Customer Satisfaction Notification M04 Engine Oil Addendum Card and Tip Card

2012 (LC/LD) Dodge Challenger SRT and Charger SRT

(LX) Chrysler 300 SRT

2012 (WK) Jeep_® Grand Cherokee SRT

Figure 1 - Sun Visor Tip Card

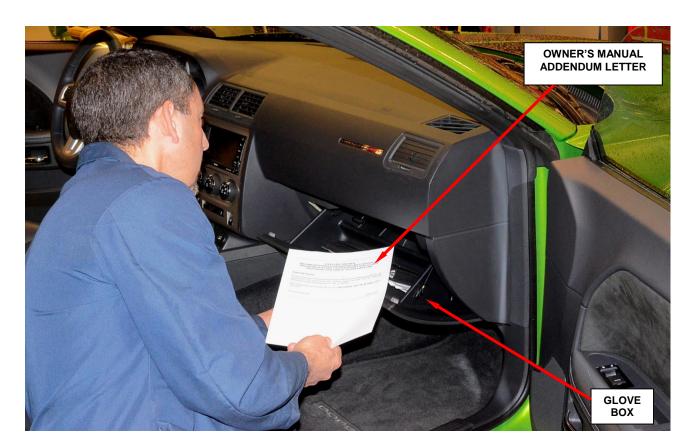
The User Guide and Tip Card on about 2,600 of the above vehicles incorrectly stated the use of SAE 5W-40 engine oil instead of the correct oil which is SAE 0W-40 full synthetic engine oil.

The Tip Card located on the sun visor must be replaced and an owner's manual addendum card must be placed in the glove box.

- 1. Open the driver's door.
- 2. Remove and discard the original Tip Card from the sun visor (Figure 1).
- 3. Slide the new Tip Card onto the sun visor (Figure 1).
- 4. Open the glove box and insert the Owner's Manual Addendum letter into the vehicle's information kit (Figure 2).
- 5. Close the glove box door.

The manufacturer recommends the use of a full synthetic SAE 0W-40 engine oil or equivalent.
